Item No.: 24B-TTC-04

NCUTCD RECOMMENDATION FOR CHANGES TO THE MANUAL ON UNIFORM TRAFFIC CONTROL DEVICES

COMMITTEE / TASK FORCE: TTC Technical Committee
ITEM NUMBER: 24B-TTC-04
TOPIC: Pedestrian Channelizing Devices
ORIGIN OF REQUEST: Tim Lang – TTC Committee
AFFECTED SECTIONS OF MUTCD: Section 6K.02 Pedestrian Channelizing Devices
Figure 6K-2

Figure 6K-2. Pedestrian Channelizing Device

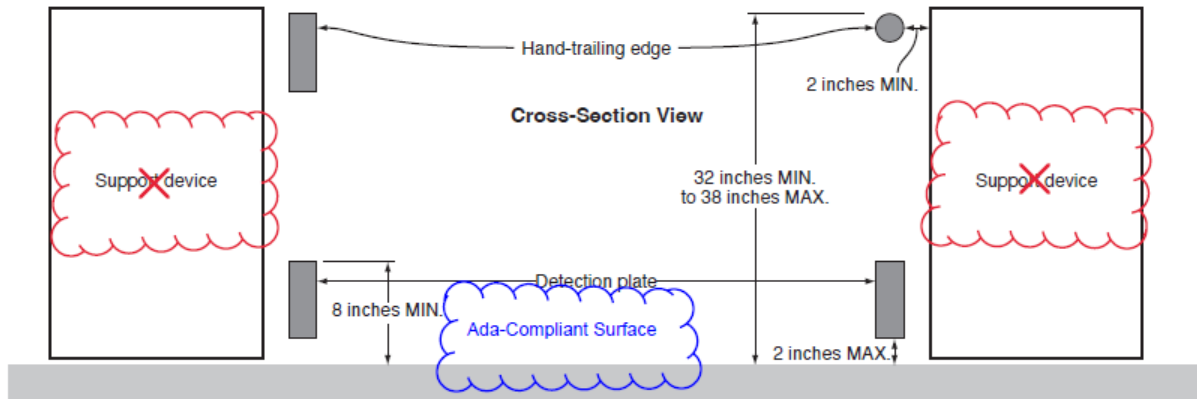
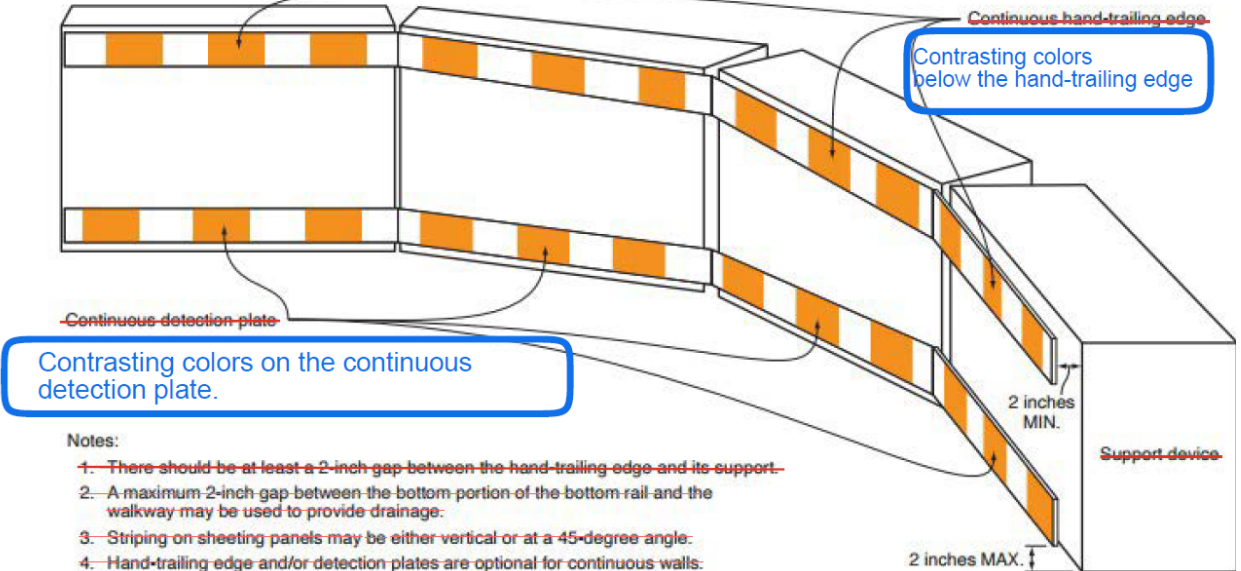
The verbiage in Section 6K.02 and Figure 6K-02 should be revised to incorporate all Pedestrian Channelizing Devices. These devices come in various shapes and sizes, and the Task Force has attempted to accommodate this diversity. The current version shows hand-trailing edges with a support device. However, not all products require a hand-trailing edge to be attached to a support device, as some have a hand-trailing edge on top. Therefore, the figure is proposed to be adjusted to include additional products.

[This is showing the proposed changes to the current drawing]

Retroreflective areas can be distributed in a manner that ensures visibility and detection without necessitating a single continuous application.

- Notes:
1. There should be at least a 2-inch gap between the hand-trailing edge and its support.
 2. A maximum 2-inch gap between the bottom portion of the bottom rail and the walkway may be used to provide drainage.
 3. Striping on sheeting panels may be either vertical or at a 45-degree angle.
 4. Hand-trailing edge and/or detection plates are optional for continuous walls.

Figure 6K-2. Pedestrian Channelizing Device

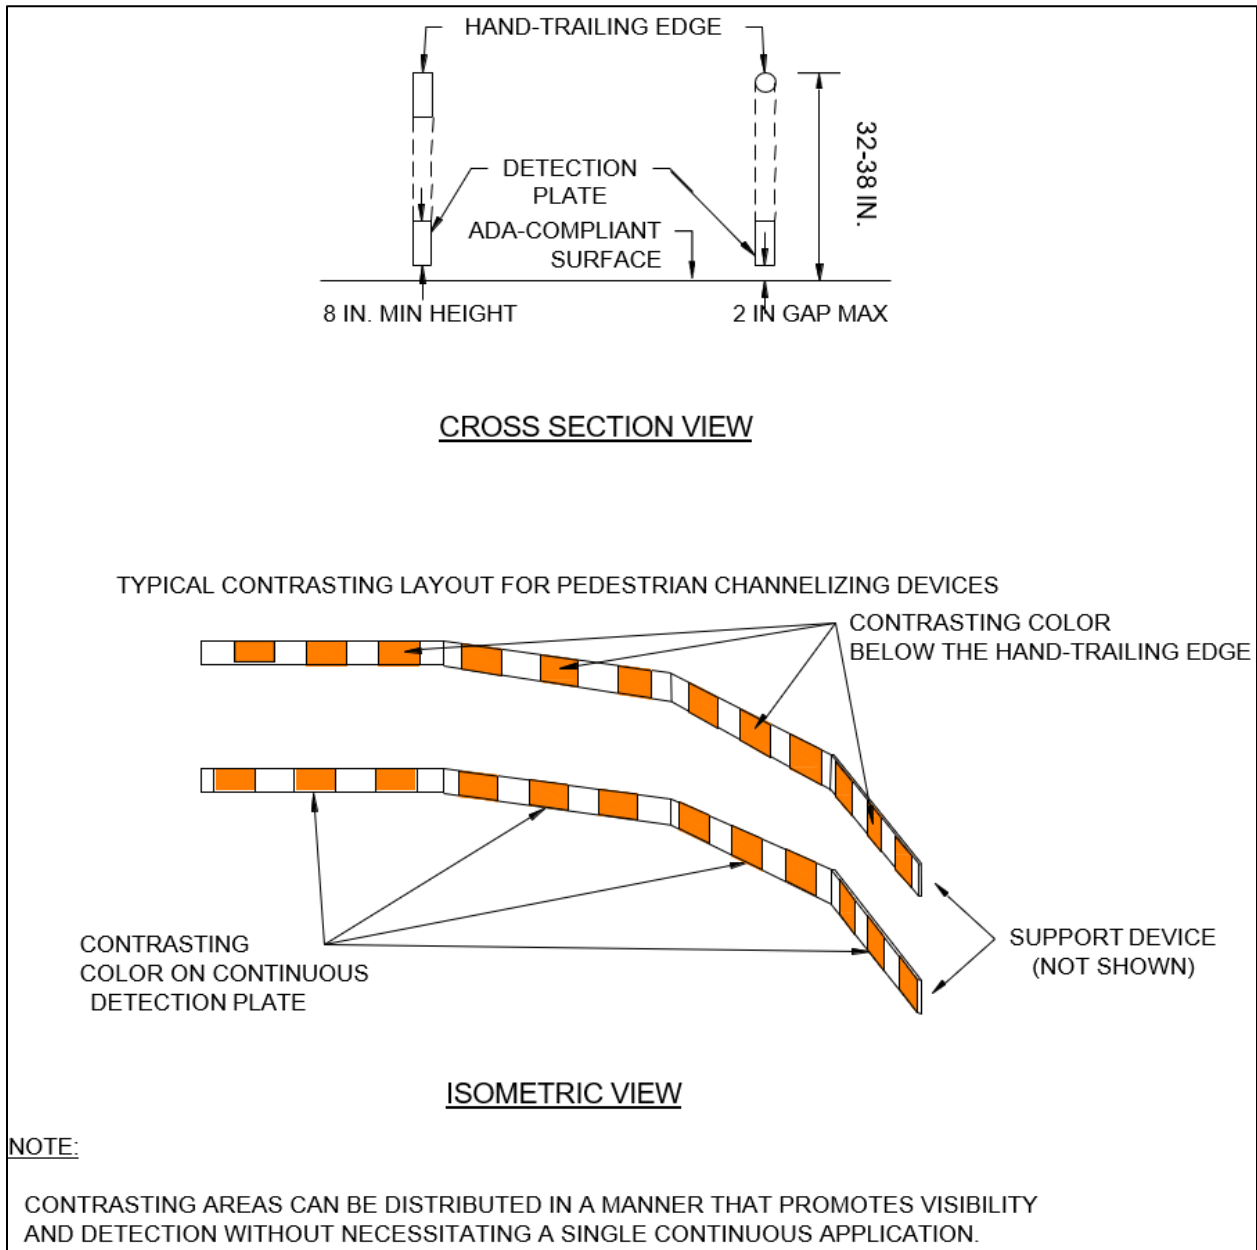
[New Drawing recommended for Figure 6K-2. This drawing was created to highlight the current design of pedestrian channelizing devices.]
